SUBJECT: ISSUANCE OF AMENDMENTS - CATAWBA NUCLEAR STATION, UNITS 1 AND 2  
HYDROGEN IGNITERS (TAC NOS. M92087 AND M92088)

DUKE POWER COMPANY  
NORTH CAROLINA ELECTRIC MEMBERSHIP CORPORATION  
SALUDA RIVER ELECTRIC COOPERATIVE, INC.  
DOCKET NO. 50-413  
CATAWBA NUCLEAR STATION, UNIT 1  
AMENDMENT TO FACILITY OPERATING LICENSE

Amendment No. 130  
License No. NPF-52

SAFETY EVALUATION BY THE OFFICE OF NUCLEAR REACTOR REGULATION  
RELATED TO AMENDMENT NO. 136 TO FACILITY OPERATING LICENSE NPF-35  
AND AMENDMENT NO. 130 TO FACILITY OPERATING LICENSE NPF-52

FIGURE

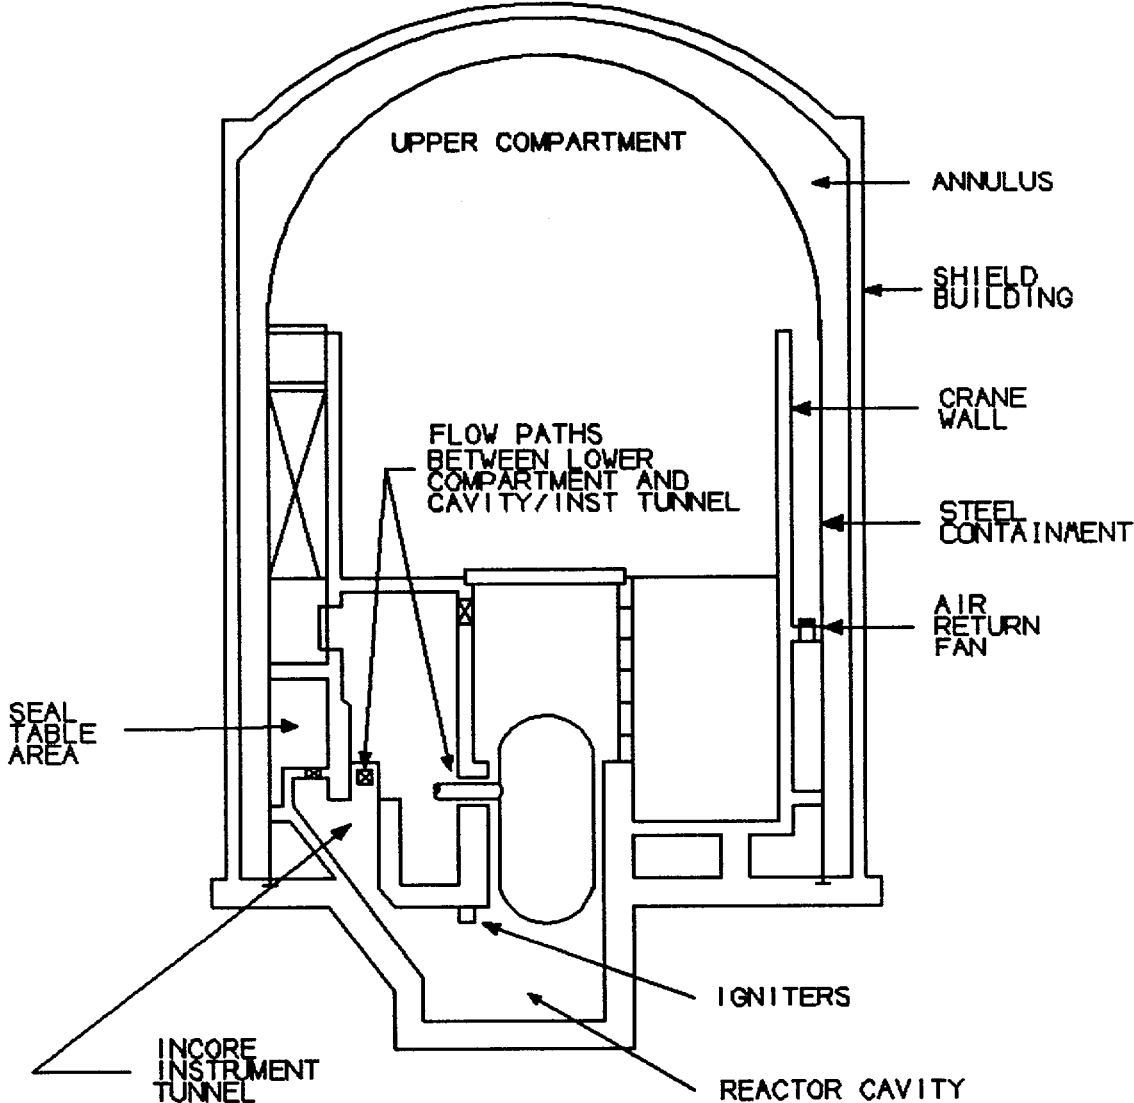
By letter dated April 10, 1995, Duke Power Company, et al. (DPC or the licensee), submitted a request for changes to the Catawba Nuclear Station, Units 1 and 2, Technical Specifications (TS). The requested changes would revise the required number of operable hydrogen igniters to allow removal of two hydrogen igniters serving the lower reactor cavity and incore instrument cable tunnel. These igniters are located in a high radiation area which poses an occupational exposure problem. The licensee has provided an analysis indicating that these two igniters are unnecessary. The attached figure depicts the location of the pair of igniters which are the subject of this evaluation.

The staff gave careful consideration to the igniter selection as part of its review. The original computer models used by the staff and applicants did not model the cavity/instrument tunnel space as a separate compartment. A detailed description of the McGuire and Catawba igniter systems, including discussions of background experiments, analyses, and research, is provided in "An Analysis of Hydrogen Control Measures at McGuire Nuclear Station", Revision 16, transmitted by letter dated August 5, 1993, from M. S. Tuckman, DPC, to the NRC, a three-volume document known as the "Redbook." The igniter system at Catawba consists of 72 glow plug igniters arranged in two trains. Each protected area is served by two independently powered igniters (Ref: DPC response to the July 21, 1981, NRC Request for Additional Information). All compartments are provided with direct igniter coverage. According to the Redbook, the McGuire and Catawba igniter systems are identical except for minor differences in terminal box designation and igniter location (but not total number). Additional igniters are provided that are not included in the Sequoyah/Watts Bar/D.C. Cook facilities, each of which have 68 igniters. The pair of igniters that the licensee has requested to eliminate at Catawba are among those. (See attached figure)

The Catawba Hydrogen Mitigation System (HMS) was designed to provide direct hydrogen igniter coverage for all compartments in the containment (Ref: Redbook 3.4). This was a licensee initiative that resulted in the installation of additional igniters at Catawba and McGuire located in an area not included in the Sequoyah lead HMS design. (The HMS at Sequoyah was reviewed as the "lead HMS design".) As noted above, the locations of concern for this review were not identified as being separate compartments or locations and were treated and analyzed as being contiguous portions of the lower containment area. The containment arrangements of the Tennessee Valley Authority and DPC ice condenser facilities are sufficiently similar that the approved Sequoyah locations, as described in the aforementioned Sequoyah SER, are considered sufficient with respect to mitigation of hydrogen combustion scenarios encompassed by the hydrogen rule. Based on the results of the original lead HMS review, the existing pair of igniters located in the lower reactor cavity can be removed from the required operability list.

In the April 10, 1995, application, the licensee provided a discussion of supporting analyses. The analyses performed by the licensee utilized the HECTR code and MAAP code. The reactor cavity subcompartment area was modeled as a separate compartment joined by one and two junctions (separate cases) to the lower compartment. Accident sequences selected to reflect the 10 CFR 50.44 recoverable (in vessel) degraded core scenarios were analyzed; four loss-of-coolant accident (LOCA) scenarios with HECTR and one with MAAP. For MAAP, only a small break was analyzed since HECTR results indicated that all four cases produced similar behavior. The HECTR and MAAP results indicated that hydrogen concentration in the cavity is maintained below 4% (non-combustible) when one flow junction is modeled. With both junctions modeled, mixing with the lower compartment occurs. This precludes the potential for a higher hydrogen concentration in the cavity than exists in the igniter-covered lower compartment.

Based on the information provided above, the results of the lead HMS review, and the licensee's supporting information, the staff concludes that the pair of igniters installed in the lower reactor cavity need not be required to be operable.
